# TECHNICAL SERVICE BULLETIN: 104756-000

## Cessna 182 Pitch Servo Capstan Position, Rev A

Original Bulletin: July 21, 2023

**Figure 1: Correct Pitch Servo Capstan Installation**

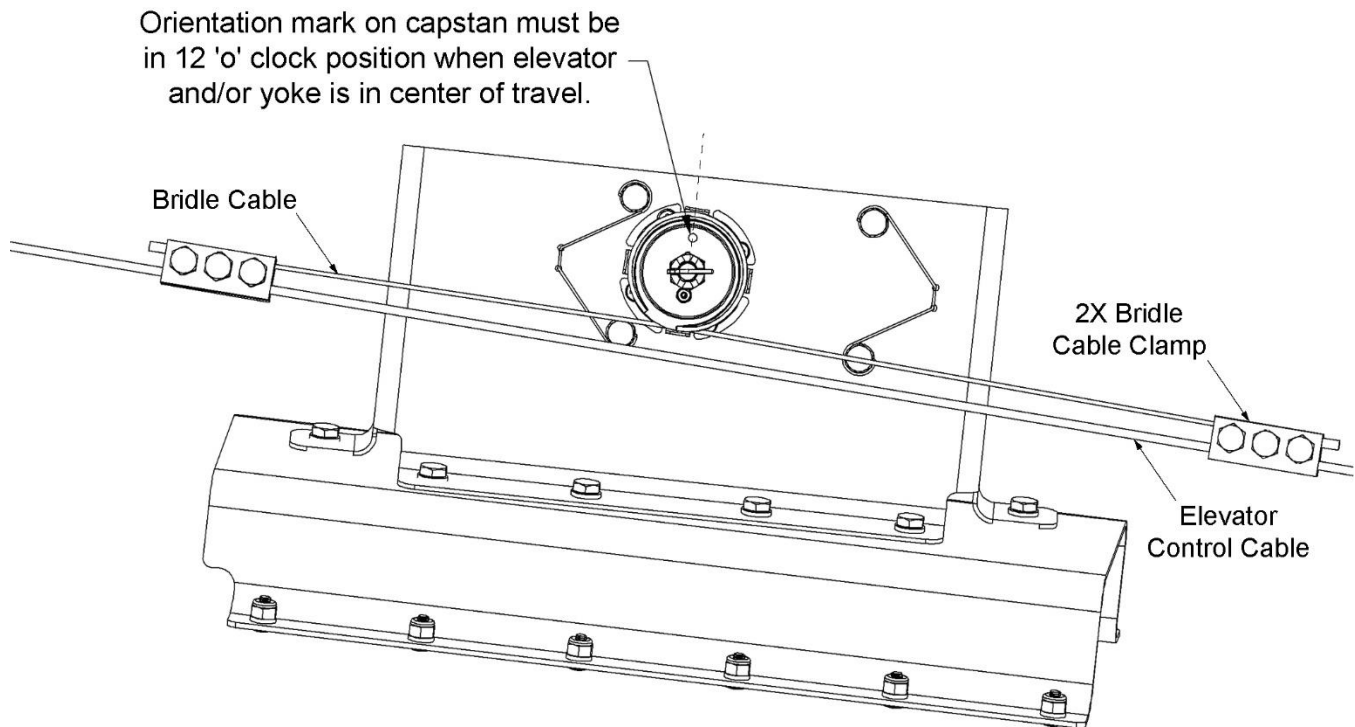
Dynon learned that the pitch servo capstan may be out of position in Cessna 182 models with fixed landing gear. Although Dynon has received no reports of any such out-of-position capstans in the field, this bulletin provides details on how to check, and if necessary, fix an out-of-position pitch servo capstan.

1. Secure elevator and/or yoke in center of travel.
2. Disconnect aircraft power.
3. Access pitch servo installation between FS172 and FS185 in accordance with manufacturer's service manual.
4. If required for access, remove aircraft battery in accordance with manufacturer's service manual.
5. Visually inspect pitch servo installation and ensure capstan is positioned as shown in [Figure 1](#).

6. If pitch servo capstan is positioned as shown in [Figure 1](#), no further action is required.
7. If pitch servo capstan is not positioned as shown in [Figure 1](#), the aircraft is to be considered grounded until pitch servo capstan is positioned correctly (see procedure below).

4. If required for access, remove aircraft battery in accordance with manufacturer's service manual.
5. Secure (e.g., tape) bridle cable ([Figure 1](#)) to capstan to prevent unwrapping.

6. Loosen, but do not remove, cable clamps ([Figure 1](#)) to disconnect bridle cable from the elevator control cable.
7. Loosen bridle cable tension around capstan, but do not let bridle cable unwrap.

8. Rotate capstan until orientation mark is in 12 'o' clock position ([Figure 1](#)).
9. Tension and connect bridle cable to elevator control cable per instructions Section 7.3.1: Fixed Landing Gear Airplanes\*.
